APPEAL # 4

Case Number: 2021-2355-ZC

Zoning Request: A-4A to A-4A and PUD

ZONING STAFF REPORT

HONEYBEE SUBDIVISION
GREEN SPACE EXHIBIT AND CIRCULATION PLAN

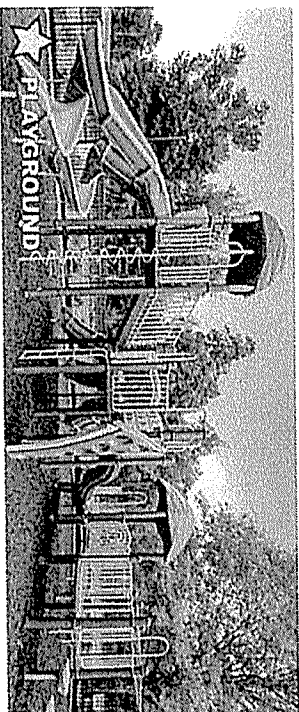
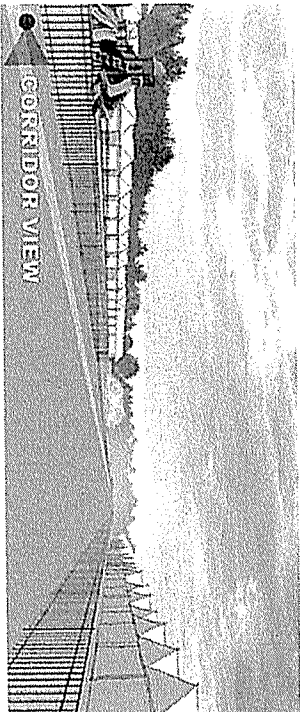
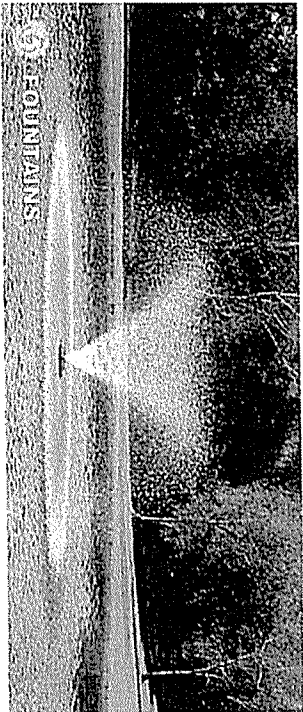
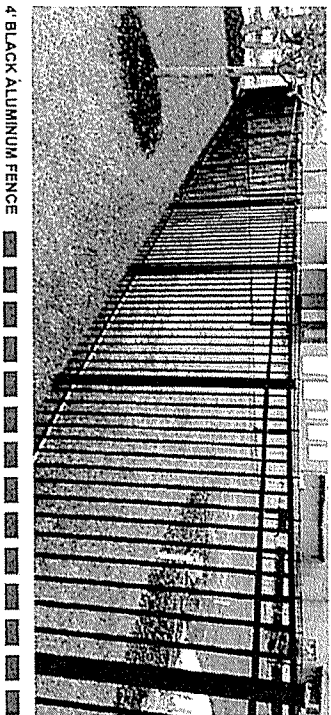
Staff has concerns that a large majority of the greenspace provided is comprised of easements, servitudes, and buffers, and therefore does not meet the intent of the PUD requirements is not of a higher quality than would be possible without the PUD. (see Table 4). While not opposed to the addition of several acres of pocket parks situated throughout the PUD, staff would like to see that more amenities are added to these parks to ensure the greenspace that is provided is functional and beneficial to the residents. Currently, it appears as though the Honeybee PUD is providing three playground sets and an “open field” to accommodate 962 proposed home sites. As per Table 4, if the applicant eliminated Bayou Paquet, the gas servitude, “space around the lakes”, and buffers from the total amount of greenspace provided, the PUD plan would be providing 36.59 acres, which is merely 53% of the greenspace required.

*This illustration is not meant to show that the proposed amenities would not meet the subdivision ordinance, but rather to note that 47% of the greenspace provided on the PUD plan is comprised of easements, servitudes, and buffers which would not be permitted if the property were to be developed without the PUD overlay and is therefore not of a higher quality.

Response: Per Section 130-1674(a)(8)(c), the proposed PUD that has been developed and submitted to staff meets the minimum open space requirements. A copy of this ordinance is below for your reference.

As you can see above, the Ordinance has specific width and size requirements in order for an area to count as open space. The areas counted on the provided PUD exhibit meet the width and size requirements. The Staff comments do not take into account that the Bayou Paquet buffer and the existing gas servitude are being amenitized by adding a sidewalk that connects to the other neighborhood sidewalks. They also do not provide credit that these areas allow every house to be in walking distance of a park with the majority of the neighborhood being in walking distance of two parks. Please note that the PUD requirements nor the subdivision requirements require sidewalks, thus this development is going above and beyond code requirements.

Not For Construction
P.U.D. WALKING
EXHIBIT

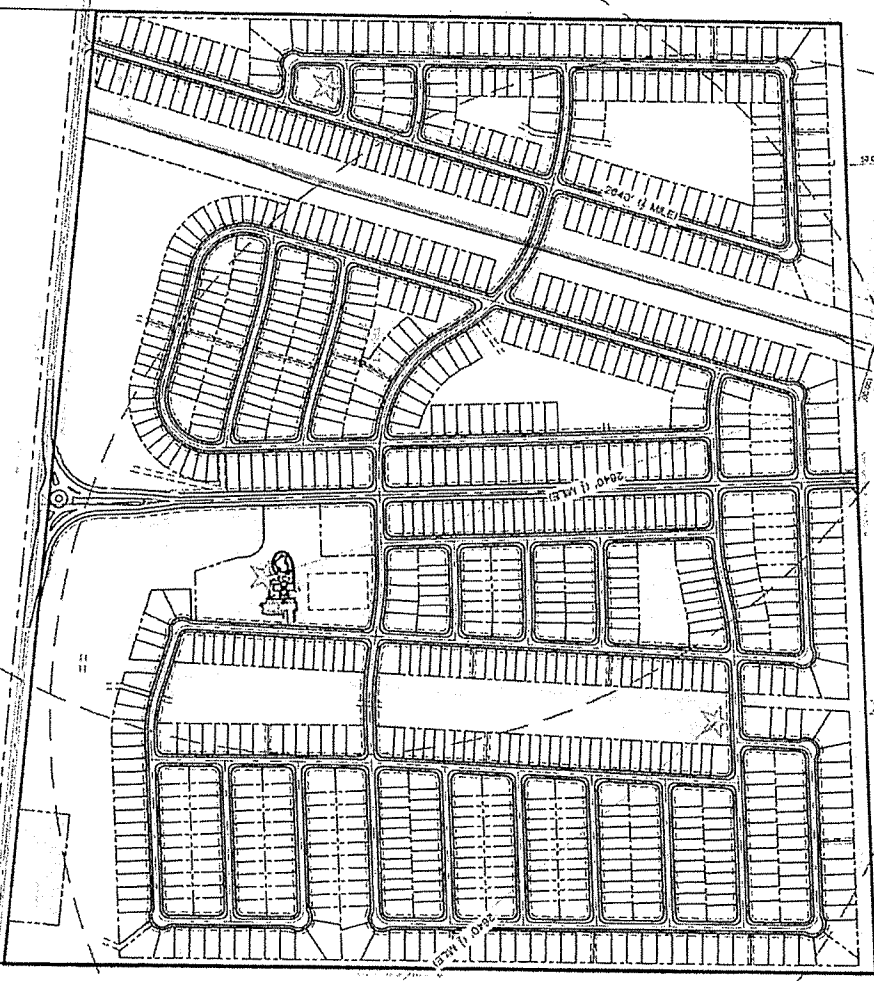
- The applicant has provided a "PUD Walking Exhibit" which shows a ½ mile radius circle centered on each park location. This plan illustrates that every lot in the development is within ½ mile from a playground. In addition, the developer has agreed to add parking at all playground locations to ensure that every home has reasonable access.
